CERTIFICATE OF APPROPRIATENESS

Property: RES A BLK 1
Riverside General
3204 Ennis St
Houston, TX 77004

- Proposal:** Alteration / Addition – The applicant is proposing to:
- Add an elevator shaft for egress.
 - Add ADA ramps for egress and accessibility.
 - Have all the wood windows repaired and refurbished.
 - Install new wood windows to match existing as needed

FIRST FLOOR PLAN PROPOSED

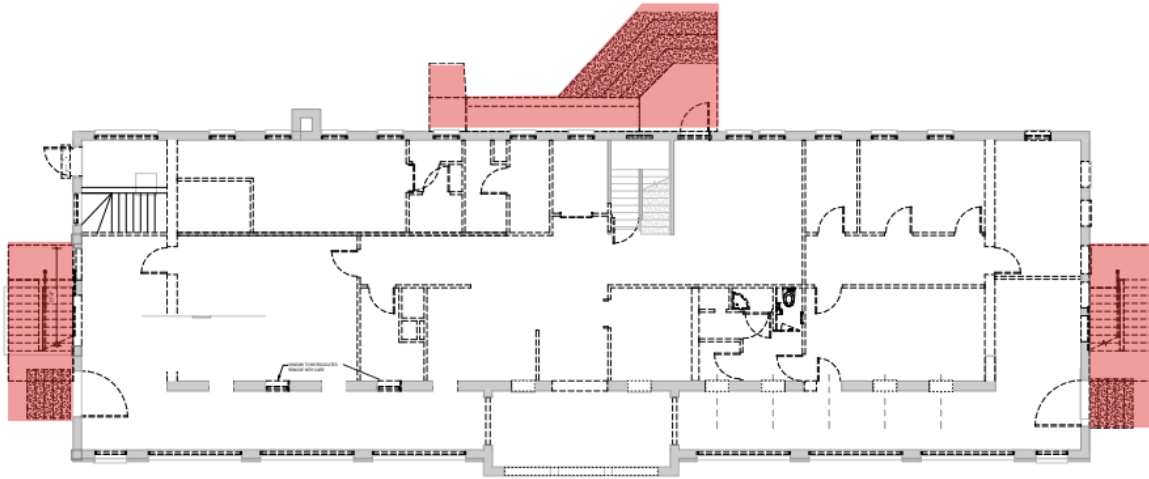
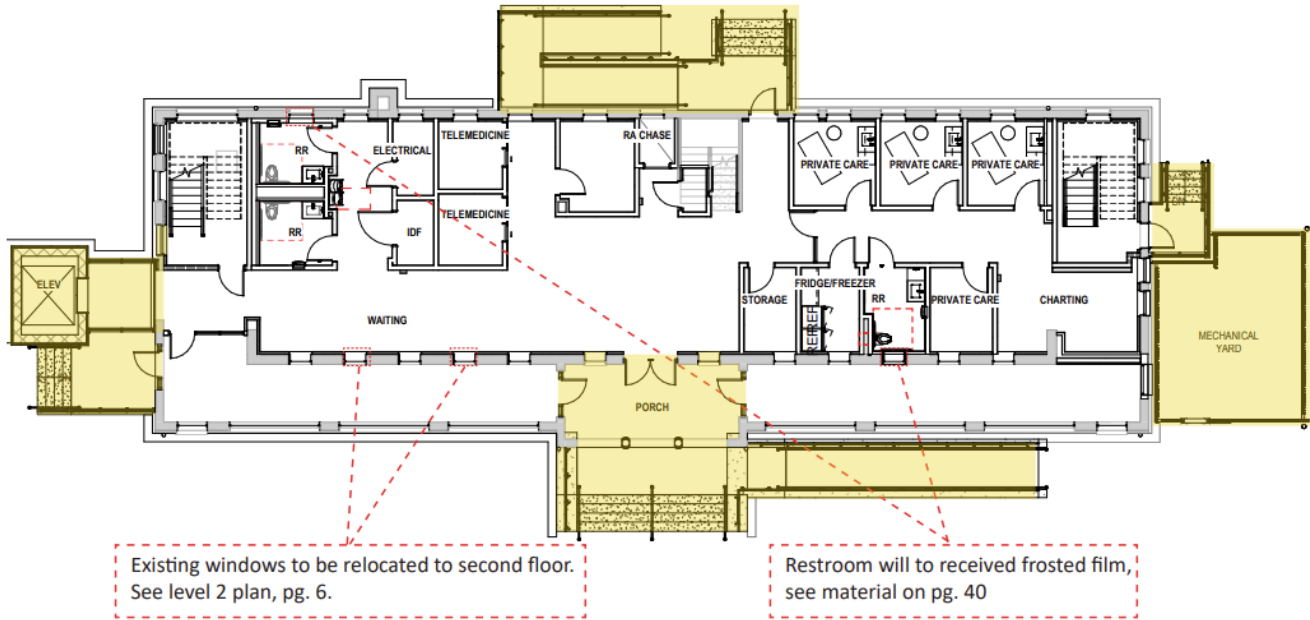
Existing windows to be relocated to second floor.
See level 2 plan, pg. 6.

Restroom will to received frosted film,
see material on pg. 40

SECOND FLOOR PLAN
PROPOSED

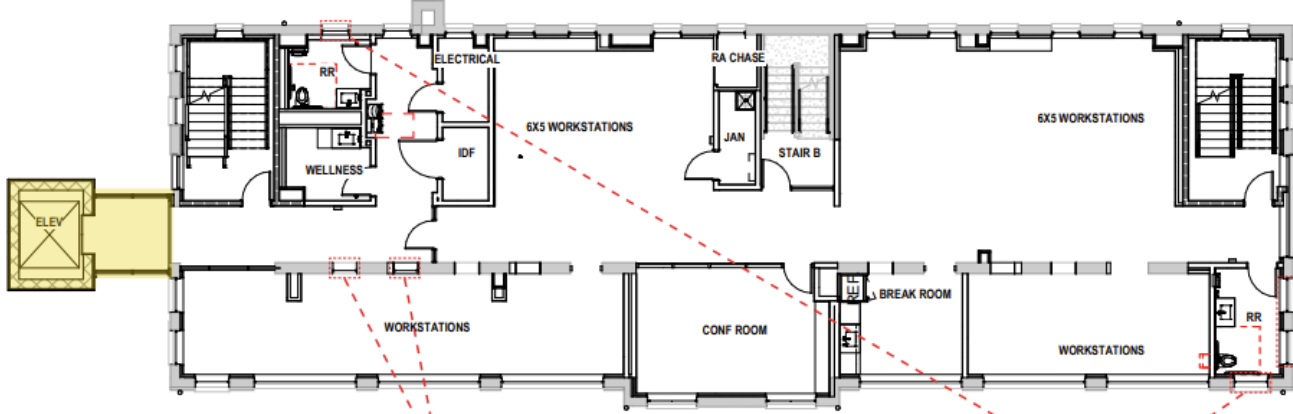
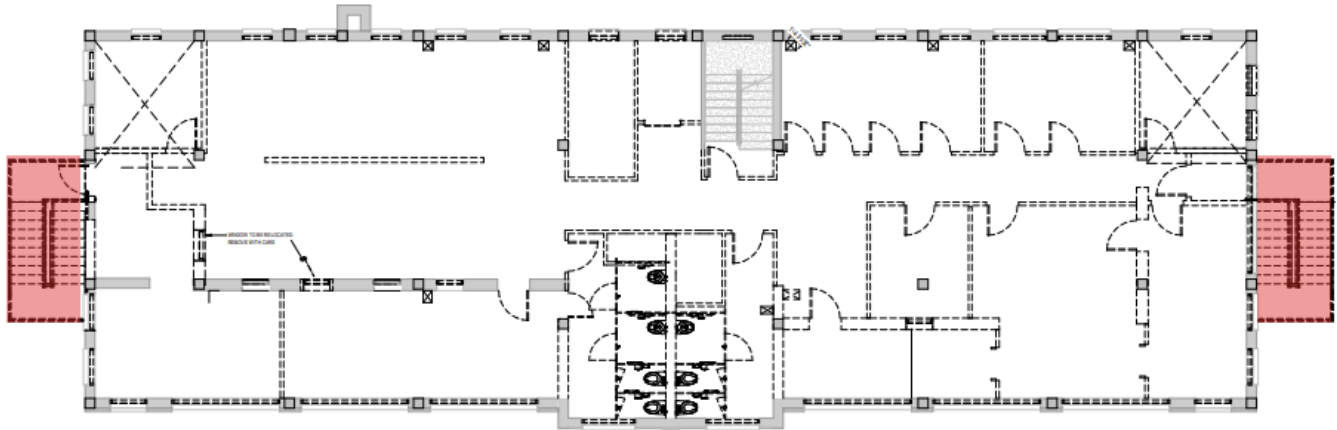
Existing windows from level 1 porch wall to be relocated to these locations.

Restroom will to received frosted film, see material on pg. 40

THIRD FLOOR PLAN
PROPOSED

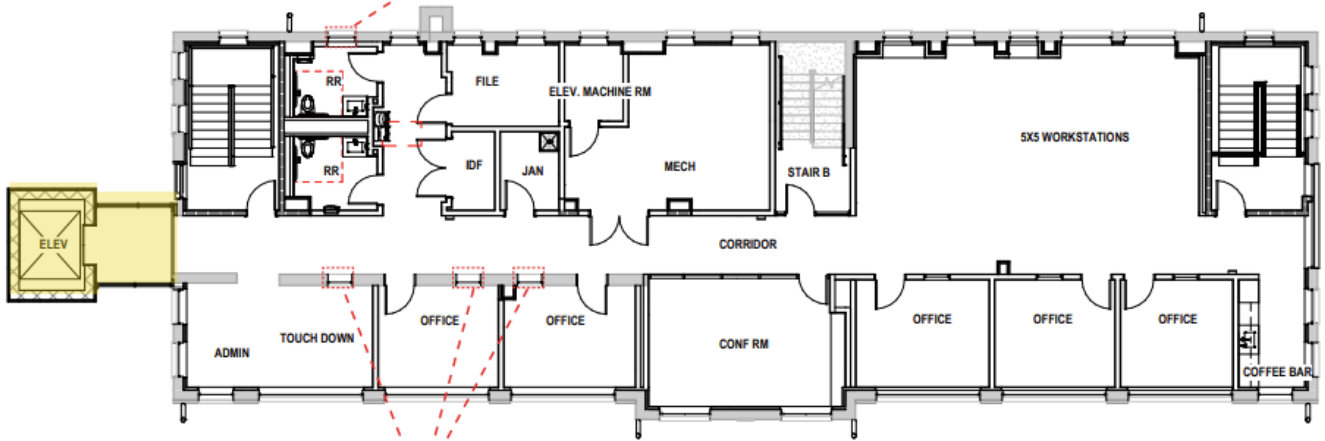
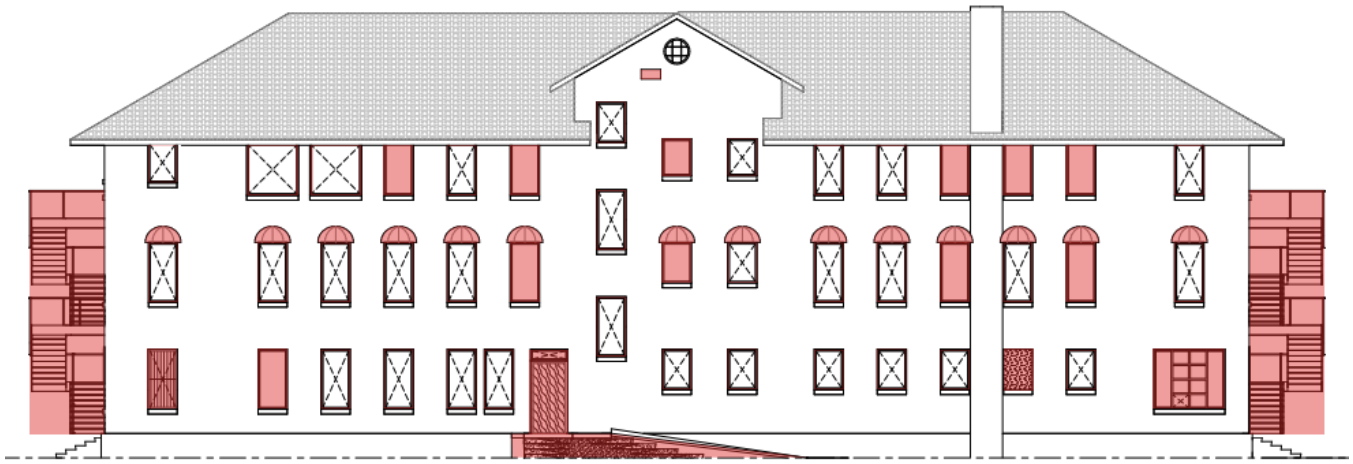
Restroom will to received frosted film,
see material on pg. 40

Existing windows to remain
